From: Jayson Haskell <jayson@dmroma.com>
Sent: Tuesday, December 3, 2019 8:27 PM
To: Jennifer Curtis
Cc: 'Dustin Roma'
Subject: RE: Depot Street - Preliminary Major Subdivision and Site Plan Completeness
Attachments: Review Comments
PWD Coordination - Depot Street.pdf; Firmette2.pdf; Firmette1.pdf; Maine Historic Approval Letter.pdf; Beginning with Habitats.pdf

From: Jennifer Curtis <jcurtis@windhammaine.us>
Date: November 26, 2019 at 4:12:25 PM EST
To: 'Dustin Roma' <dustin@dmroma.com>, Jayson Haskell <jayson@dmroma.com>
Subject: Depot Street - Preliminary Major Subdivision and Site Plan Completeness Review Comments

I reviewed the Depot Street Preliminary Plan application for completeness and found that it needs the following (some of these were marked "Pending" in the application checklist):

COMMUNITY-PANEL NUMBER
230189 0025 B

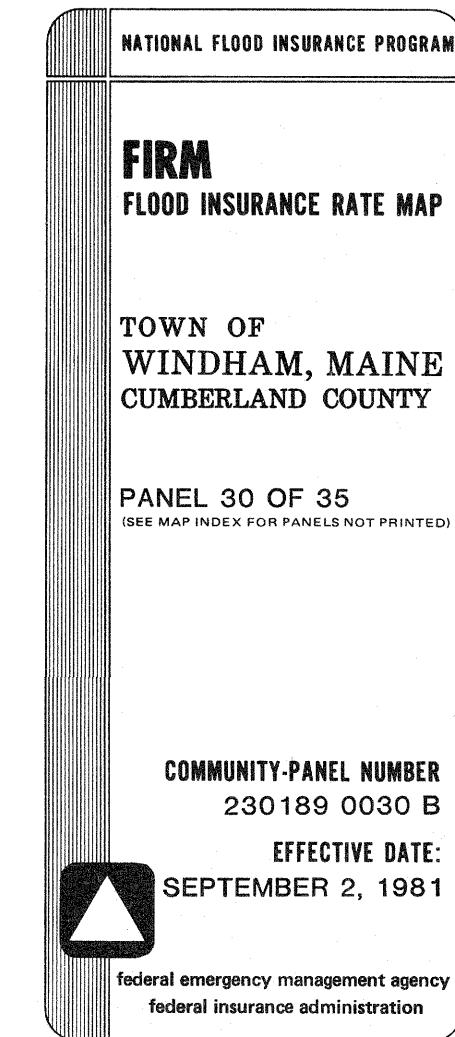
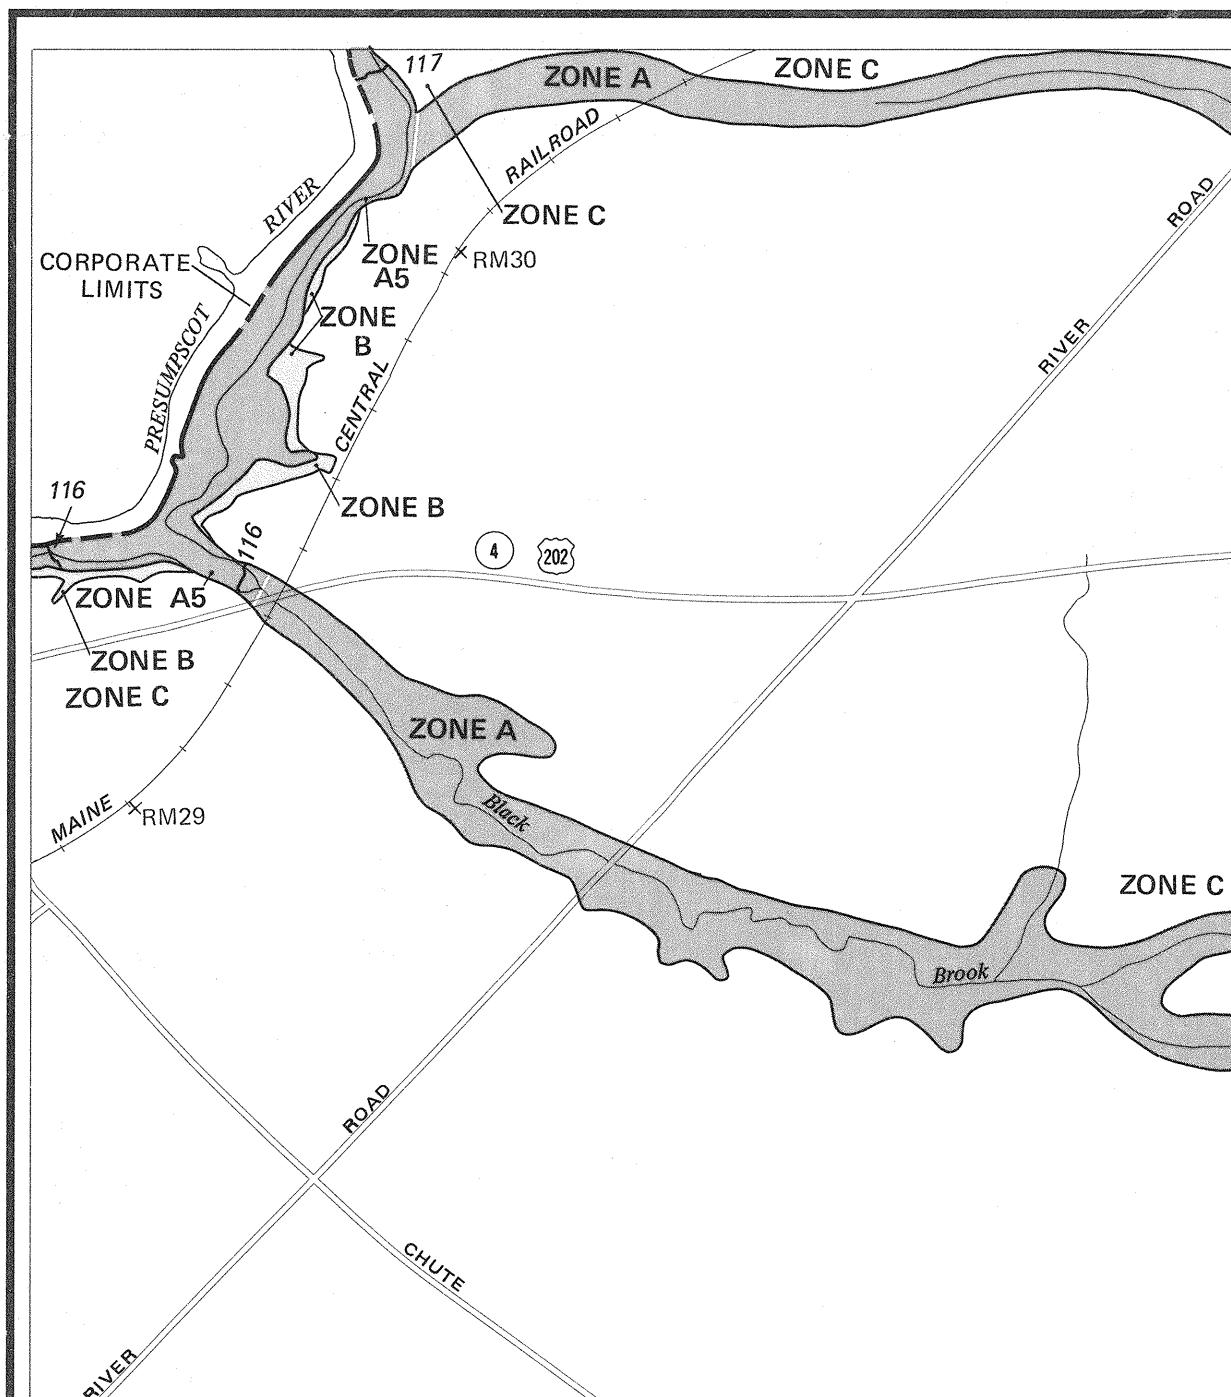
- State or show extents of floodplain on the site

The property is not located in a FEMA defined flood plain. Attached are the two firm panels indicating this.
